**SUBMITTAL TO THE BOARD OF SUPERVISORS  
COUNTY OF RIVERSIDE, STATE OF CALIFORNIA**

**SUBJECT:** TRANSPORTATION AND LAND MANAGEMENT AGENCY/TRANSPORTATION: Approve Addenda to Plans and Specifications, Accept the Low Bid and Award the Contract for the Construction of the Girard Street Resurfacing and Acacia Avenue Drainage Repair and Resurfacing, the Rosalie Avenue and Caroline Court Resurfacing Project, and the Valle Vista Library Parking Lot Paving Project, in the Communities of East Hemet and Valle Vista. CEQA Exempt, District 3. [\$5,592,526 Total Cost - Local Funds 100%]

The addenda were issued to supplement, clarify and modify the approved contract documents. The addenda are attached and designated as Addendum No. 1 and Addendum No. 2.

CONCURRED BY	PREPARED BY	TITLE	SHEET No.
<i>Mark Lancaster</i> 9/29/2022 MARK LANCASTER DIRECTOR COUNTY OF RIVERSIDE	PREPARED UNDER THE SUPERVISION OF:  9/27/2022 ENGINEERING PROJECT MANAGER COUNTY OF RIVERSIDE	<b>ROSALIE AVE. / CAROLINE CT. RESURFACING PROJECT</b>	SHEET 1 OF 3

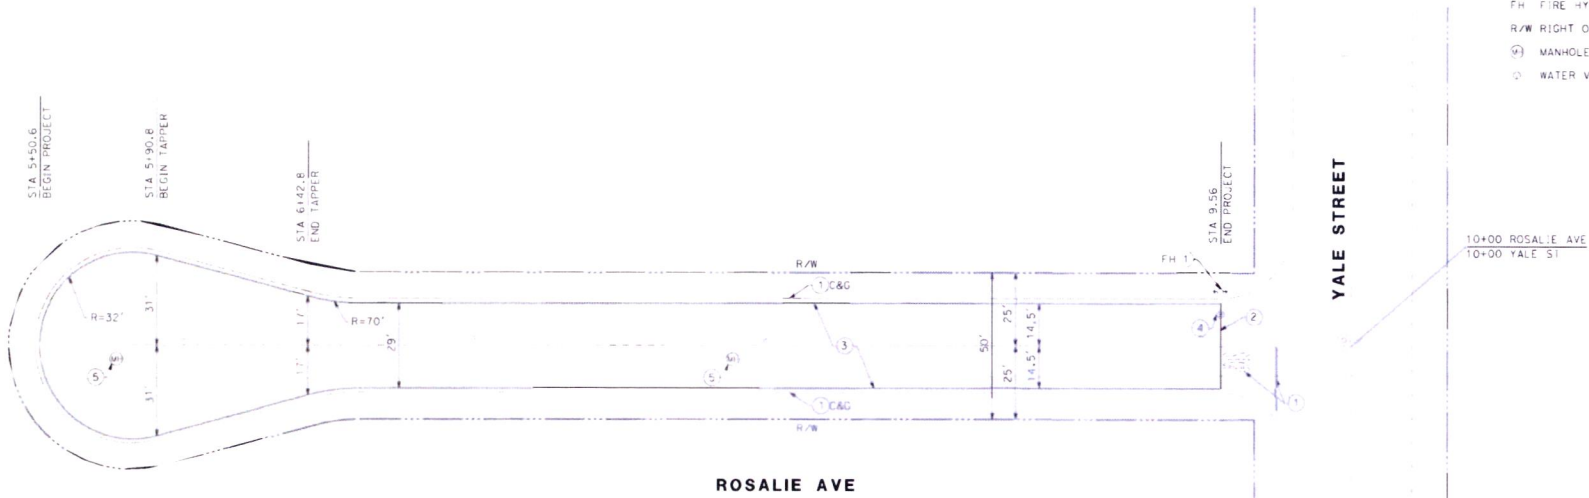
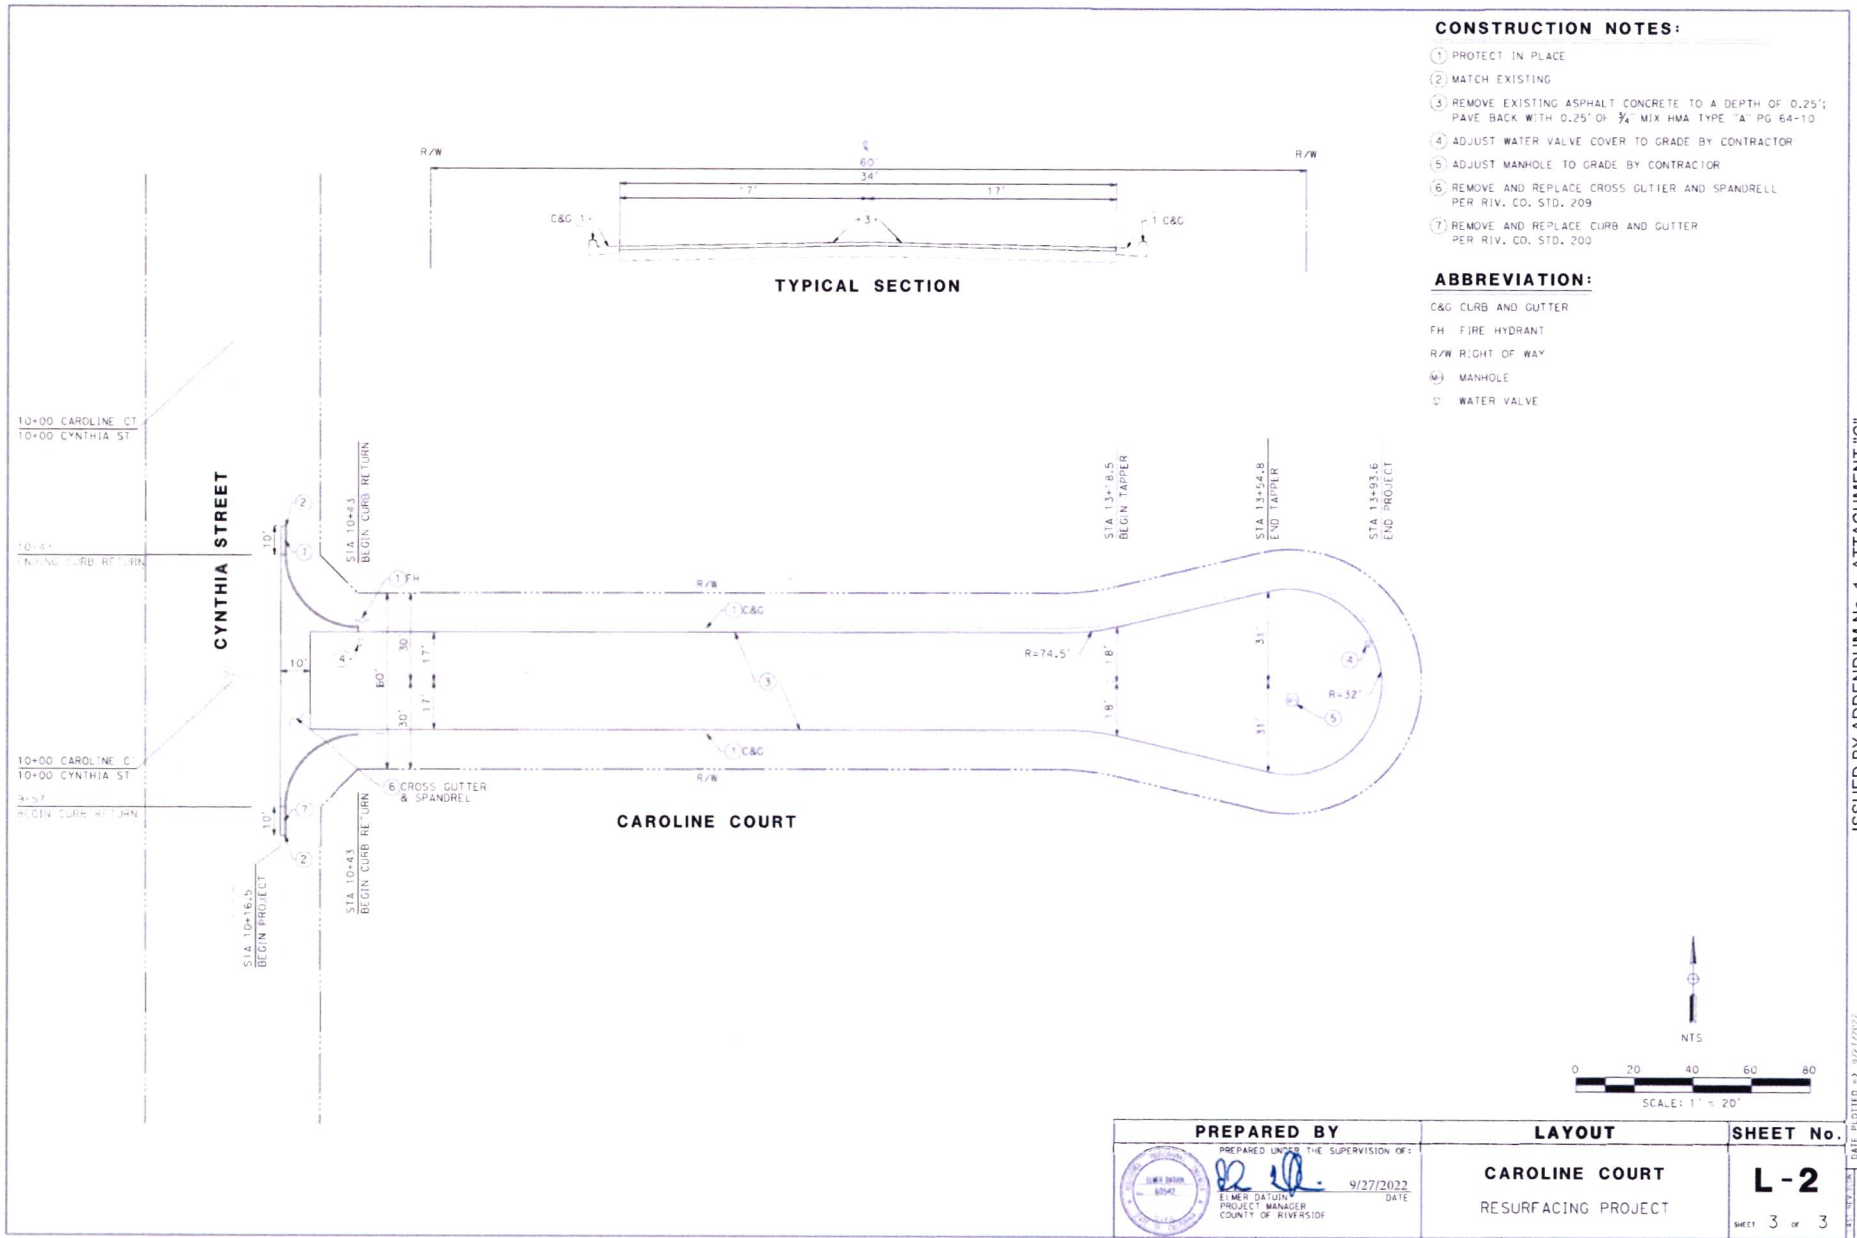
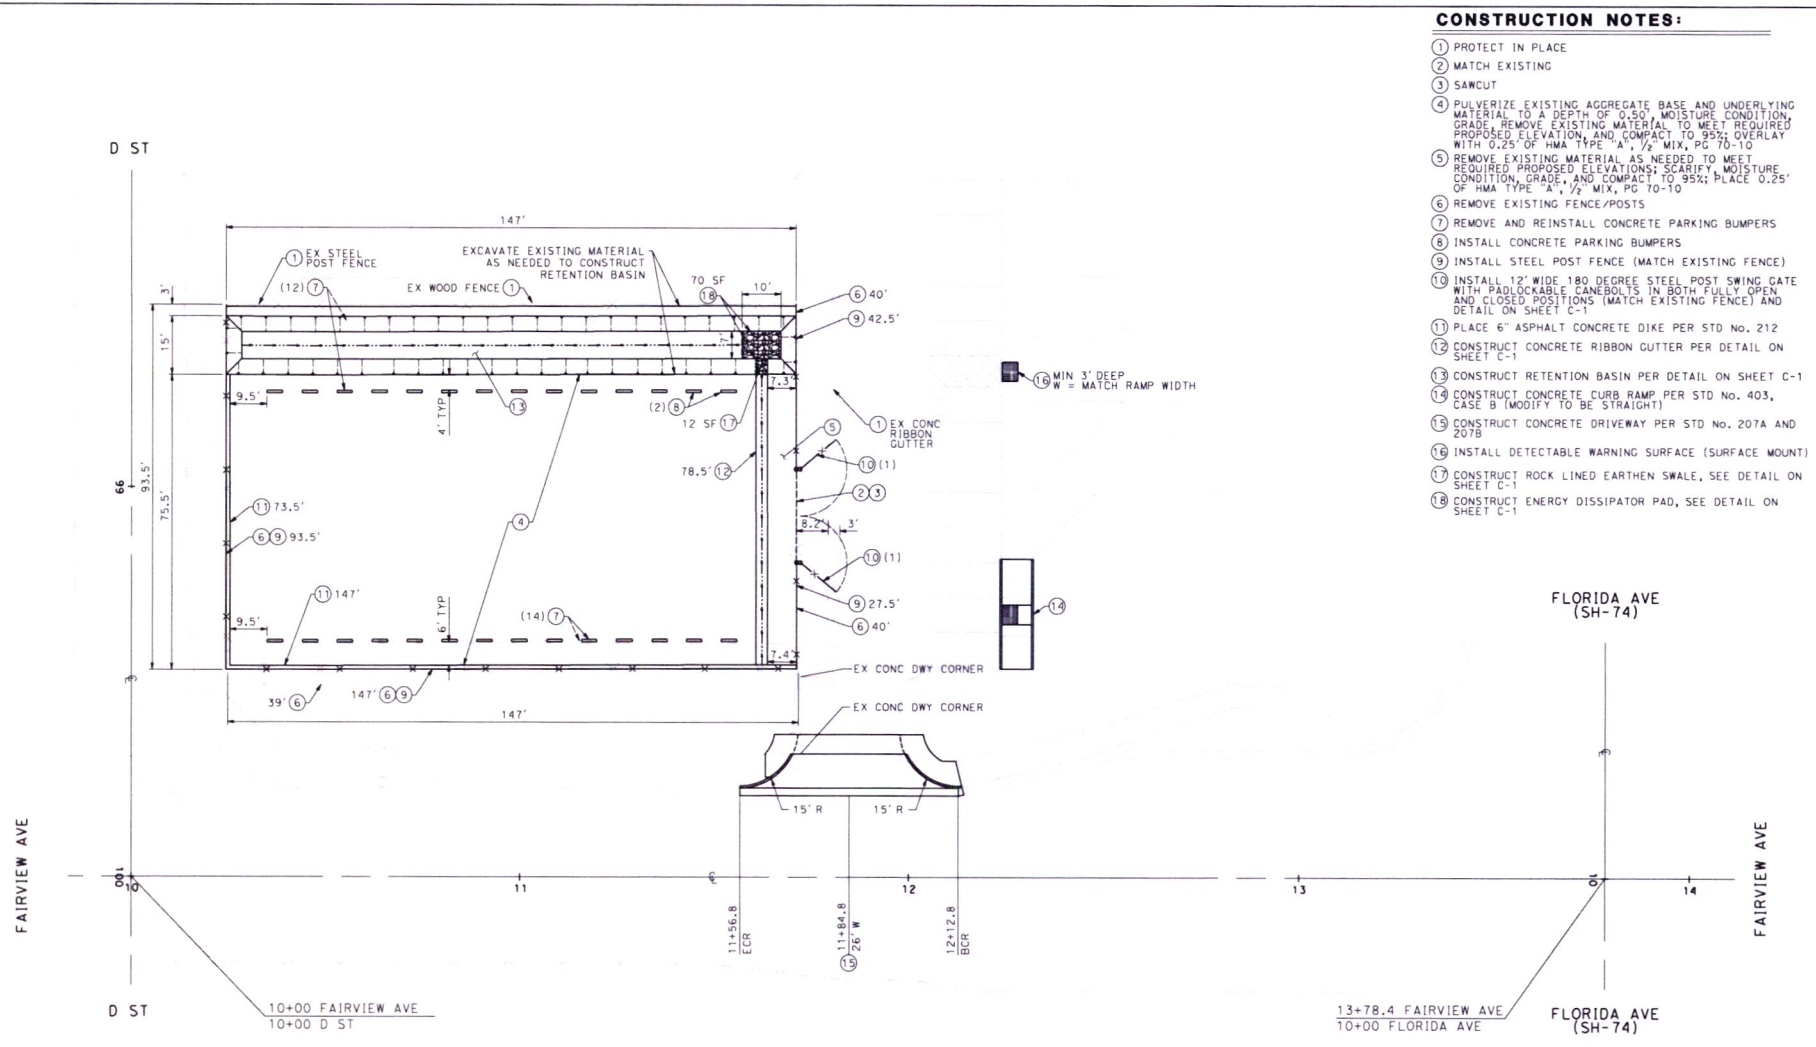
The following (8) plan sheets are added by **Attachment “C”** and are made a part hereby:

1. 3 plan sheets, Rosalie Avenue and Caroline Court Resurfacing Project
2. 5 plan sheets, Valle Vista Library Parking Lot Paving
